Documentation Description: Nonconformance Report - C-02299-V

NONCONFORMANCE REPORT

16 NCR NO.	C-02299-V	
17 DATE ISSUED	4-3-84	18 REV 0
19	PAGE 1 OF 12 ^{HAS} 40954 _{20 SUTS-184}

5 ITEM DESCRIPTION
CONCRETE PLACEMENT SWI (609) a'

1 ITEM LOCATION S.W.P.S., EL. 592' to 609', SEE ATTACHED SKETCH ON PAGE 12.

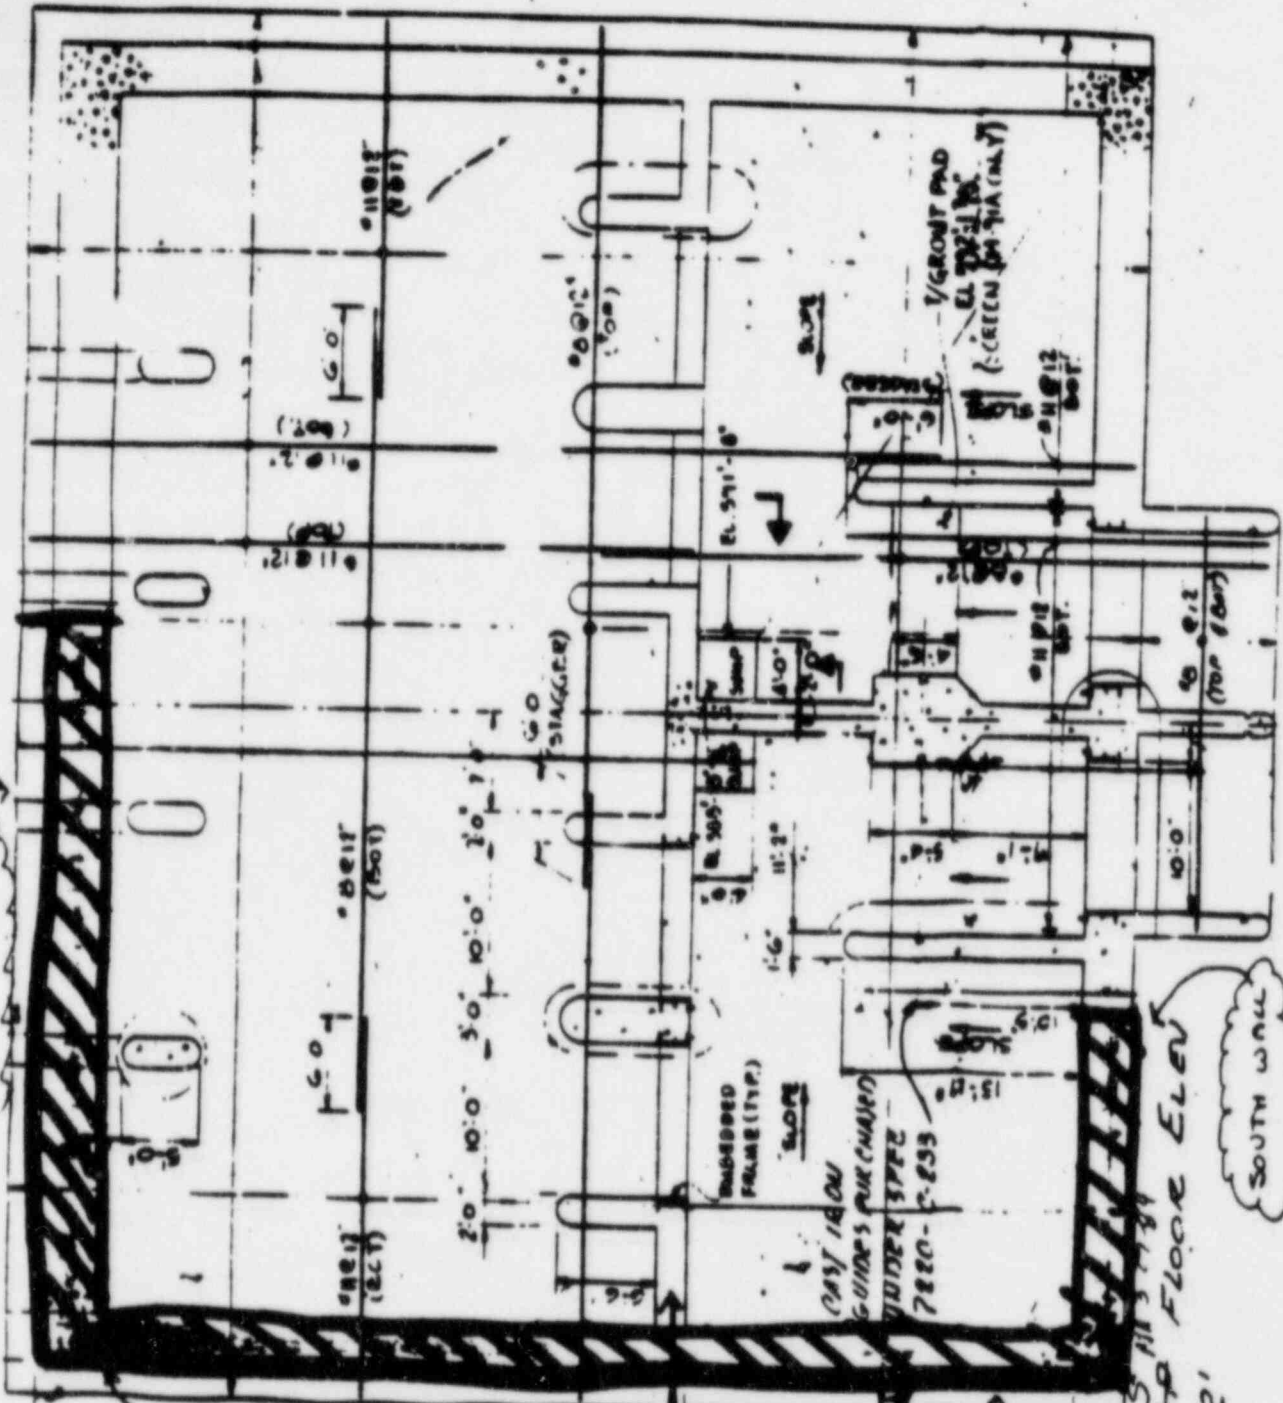
13 NONCONFORMANCE CONTRARY TO THIS, CONCRETE PLACEMENT SWI (609) a' CONTAINS THE FOLLOWING:
 A) A GROUT LEAK ALONG THE HORIZONTAL CONSTRUCTION JOINT AT EL. 609'
 B) CRACKS EXUDING WATER
 C) ~~ROSTING TIE WIRE ALL 4/14/84~~
 D) VOIDS
 E) GROUT REPAIRS - NOT TIGHTLY BONDED, HOLLOW SOUNDING OR SHOWING EVIDENCE OF MOISTURE
 F) PLYWOOD
 G) UNSOUND CONCRETE
 H) ~~CRACKS IN CONCRETE FORMS DISKS ALL 4/14/84~~

- I.) RUSTING DROP-IN ANCHORS
- J.) VERTICAL JOINT TO ADJACENT POUR ON SOUTH WALL - POORLY BONDED AND LEAKING WATER
- K.) IMPROPERLY BONDED VERTICAL CONSTRUCTION JOINT TO EAST/WEST WALL DIVIDING AREA 800E & 800F.

- B) CRACKS - BEGINNING AT THE FLOOR SLAB
 - 1.) NORTHWEST CORNER
 - 2.) DIRECTLY BEHIND 1ST WATER INTAKE ^{800W/2184} PUMP
 - 3.) 1' 11" WEST / Q PIER 1
 - 4.) 4' 0" EAST / Q PIER 1
 - 5.) 2' 6" W / Q PIER 2

- 1.) EL. 605'4" - UPPER RIGHT HAND CORNER OF WATER INTAKE PUMP #3 EMBED
- 2.) EL. 607'4", 4'2" W/C PIER 2
- 3.) EL. 607'3" BEHIND WATER INTAKE PUMP #2
- 4.) EL. 605'2", UPPER LEFT HAND CORNER OF WATER INTAKE PUMP #2 EMBED
- 5.) EL. 604', VOID AT LOWER LEFT HAND CORNER OF WATER INTAKE PUMP #2 EMBED
- 6.) EL. 608'-609' BEHIND PIER #1 (SEVERAL)

- 1.) 4'8" S / NORTH WALL
- 2.) 8' S / NORTH WALL , EL. 606
- 3.) 14'6" S / NORTH WALL , EL. 605
- 4.) 15'6" S / NORTH WALL , EL. 605
- 5.) 23'6" S / NORTH WALL
- 6.) 2'3" N / MIDDLE WALL
- 7.) 9'10" N / MIDDLE WALL
- 8.) 14' N / MIDDLE WALL
- 9.) 16'6" N / MIDDLE WALL
- 10.) 10" S / MIDDLE WALL
- 11.) 8'0" S / MIDDLE WALL
- 12.) 11'9" S / MIDDLE WALL
- 13.) 12'9" S / MIDDLE WALL
- 14.) 5' N / SOUTH WALL
- 15.) SOUTH WEST CORNER OF POUR

Pg 5 of 12 Section D Use as is. Voids are minor in nature
and does not effect the structural integrity of
the concrete.

The voids described in this item were
physically reviewed. Most voids are air voids
caused by excessive application of form
parting agent. Some rough areas were
noticed. No voids which may impair the
structural integrity were noticed.

Project Engineering concurs with field
engineering and recommends "USE AS IS"

The cracks will be monitored by Soils remedial group. See disposition of item B for west wall on page 16 of this NCR.
